# Response to An Bord Pleanála Opinion

Bailey Gibson 2 – Proposed Strategic Housing  
Development

July 2022

Figure 1 Proposed Development Site Zoning

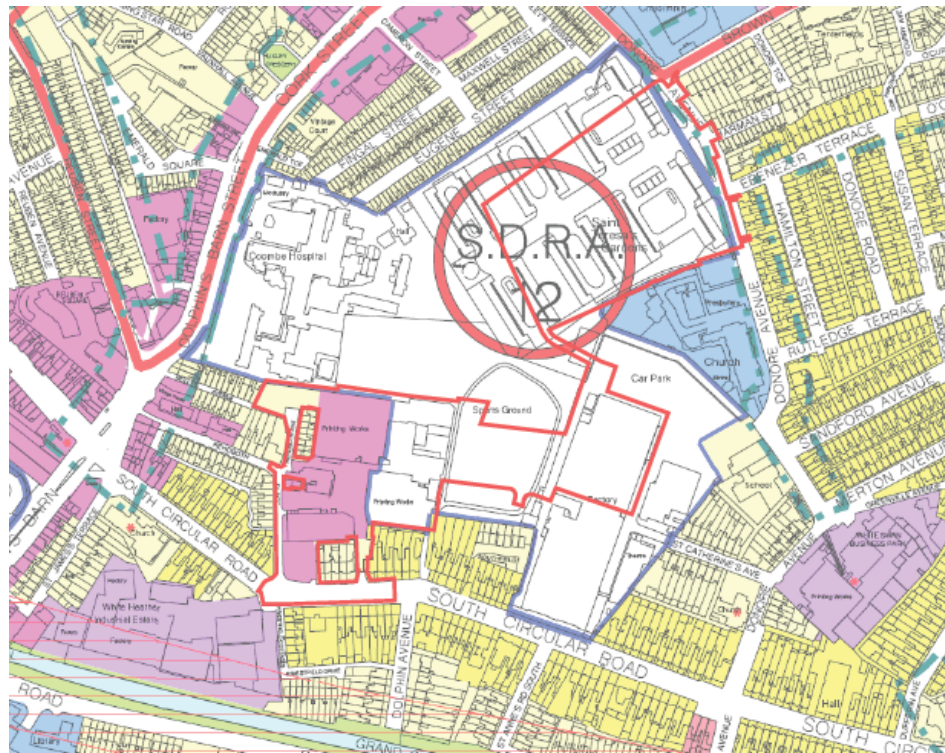
1. Further consideration of, and possible amendment to the documents submitted and justification for the proposed development with regard to compliance with the Development Plan zoning objectives relating to this site. In this regard a detailed statement of consistency and planning rationale, clearly outlining how in the prospective applicant's opinion, the proposed development is compliant with local planning policies and in particular the Z4 - District Centres zoning objective, which aims 'To provide for and improve mixed-services facilities.' This may require possible amendment to the documents and/or design proposals submitted.

The Figure below is an extract from Map E of the DCDP, with the proposed application area superimposed (indicated with a red line boundary) on SDRA 12.

The majority of the proposed development site is within Z14 (shaded white).

The western portion (purple area) of the Bailey Gibson site is zoned Z4 and to the northeast of this, the yellow area is Z1.

There is a very small area (42 sq.m) hardly visible at this scale, zoned Z2. It is inside the existing entrance to the Bailey Gibson site from South Circular Road.

Where “residential” is expressly provided for and/or permissible in principle as it is for all 4 zonings attached to this proposed development site, it falls within the description of a zoning for a “...mixture of residential and other uses.”.

Figure 4 SDRA 12 (Source DCDP 2016-2022)

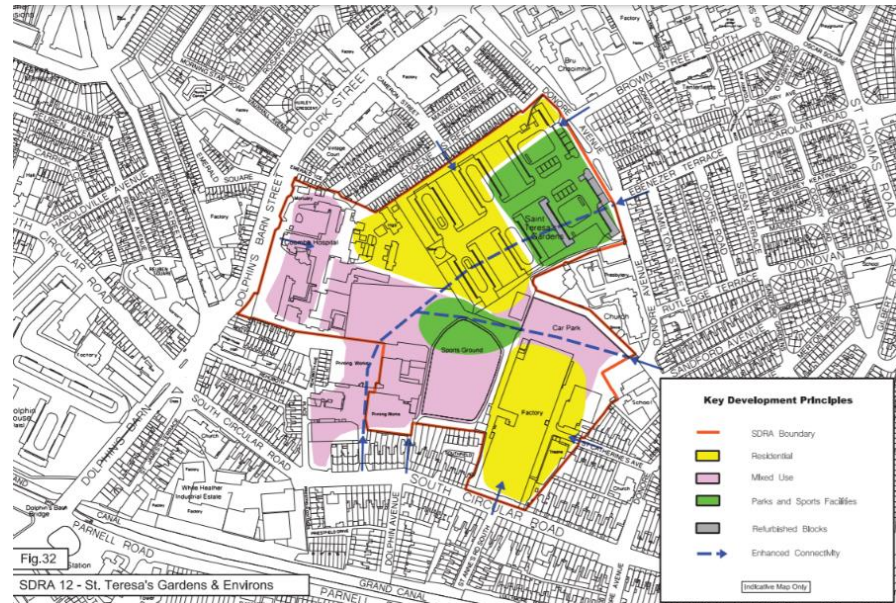
2. Further clarification of, and possible amendment to, the documents submitted with regard to the extent of the subject lands which fall within Strategic Development and Regeneration Area (SDRA) 12 as described in the Dublin City Development Plan 2016, and as outlined in Fig. 32 and Zoning Map E thereof. The application should address compliance with the relevant provisions of the plan in this regard, particularly with regard to land use and open space provision. In providing clarity in relation to this matter, the prospective applicant should also refer to the provisions of the Development Framework for St. Teresa's Gardens and Environs (DCC June 2017) which describes the status of the Bailey Gibson lands in this regard. (Map and annotation on page 5 of the Framework Plan and the table on Page 25 thereof, Public Open Space Provision).

SDRA 12 encompasses an area of 12.62 hectares including St. Teresa's Gardens, the former Player Wills and Bailey Gibson sites and the Coombe Hospital site. An Indicative Key Development Principles plan for SDRA 12 is included in Chapter 15 of the DCDP and Map E is included as an Appendix to the development plan, both are reproduced below. It is important to note that while the SDRA boundary in both plans excludes some of the Bailey Gibson site, this is not an accurate reflection of the full extent of SDRA 12.

Notably, this indicative key development principles plan applies a broad brush approach which reflects the zoning objectives for Z14 and Z4. It is clear from this plan that the intended location of the public open space was on the Dublin City Council owned land. This proposed development follows this approach but also includes Rehoboth Plaza on the Bailey Gibson site.
